CITY OF TROUTDALE

Staff Report

FILE NUMBER / NAME	LU-0002-2020 FedEx Parking Lot Expansion Lot 1 TRIP		
APPLICATION TYPE	Type III Variance, Site Development Review		
PROJECT APPLICANT	Chris Thome on behalf of FedEx	PROPERTY OWNER	Chelsey Ackerman
PROJECT LOCATION	2460 NW Sundial Road	TAX MAP / TAX LOT #	1N3E23 -00109/R843600150 and 1N3E23 -00108/R843600100
LAND USE MAP	I - Industrial	LAND USE ACTIVITY	Industrial
ZONING DISTRICT	GI – General Industrial	OVERLAY DISTRICT	None

Figure 1: MCDCM Table 2.2.2 Urban Collector Cross Sections

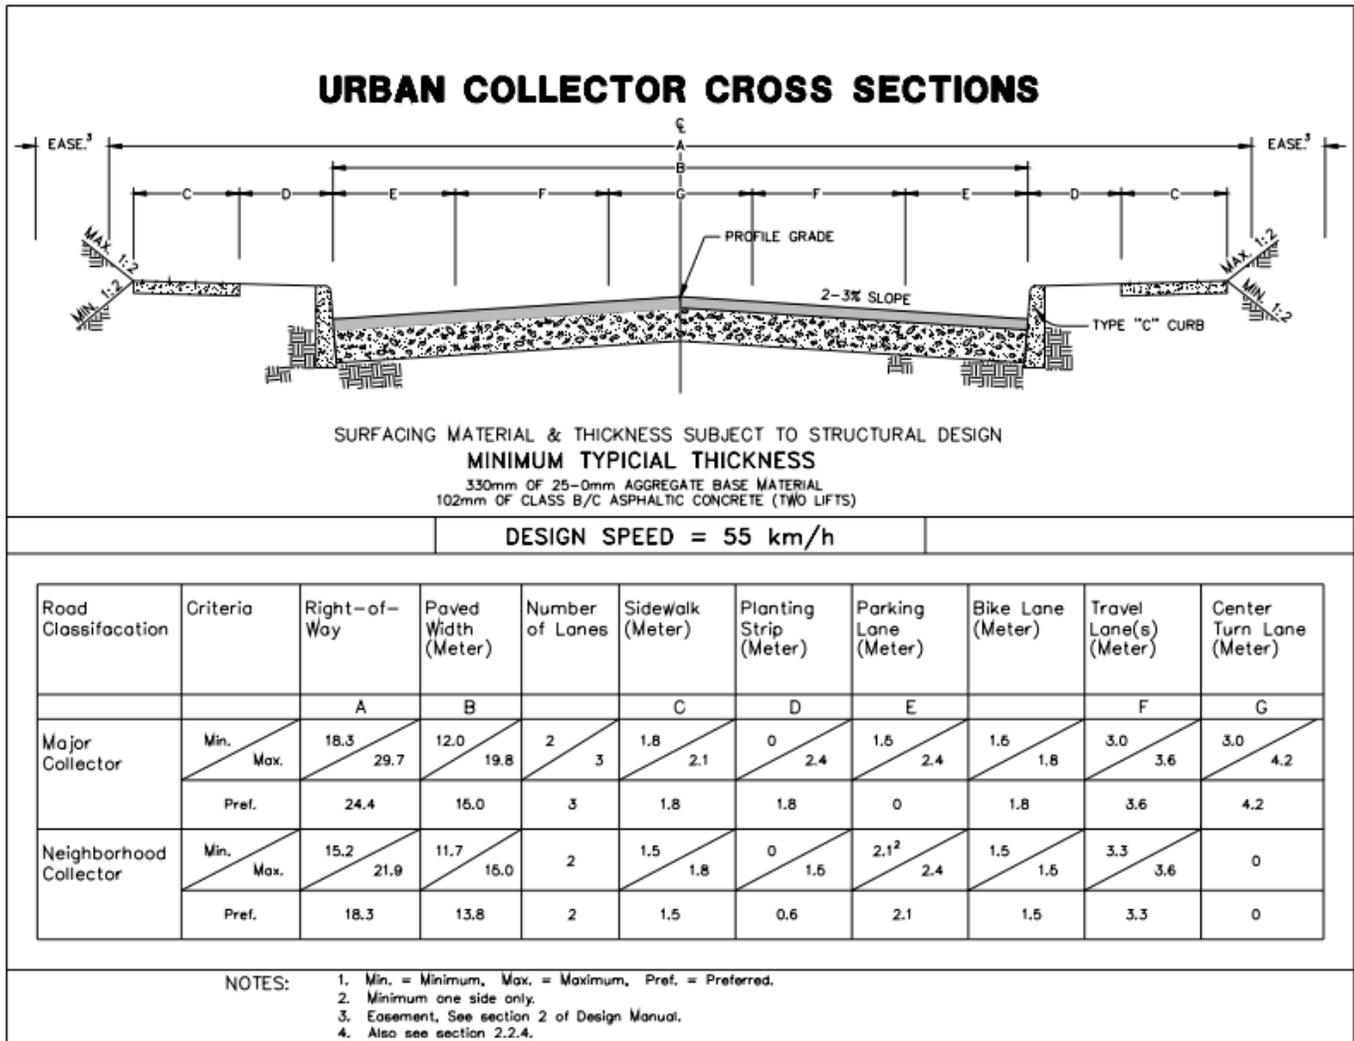
Dedicate five feet of right of way along the site's NW Sundial Road frontage to Multnomah County for road purposes. The County standard right of way for a Major Collector road is 80 feet, 40 feet from the road centerline to adjacent property lines **[MCDCM Table 2.2.2 Urban Collector Cross Section]**, as shown in Figure 1. Currently, 35 feet of right of way exist between the site's property line and the centerline of NW Sundial Road. The owner is required to dedicate five feet of right of way to Multnomah County along the property's NW Sundial Road in order to achieve a proportional share of this standard. Contact Pat Hinds at (503) 988-3712 or patrick.j.hinds@multco.us to complete the easement dedication. As part of the Troutdale Reynolds Industrial Park (TRIP) Plat, a 5 foot
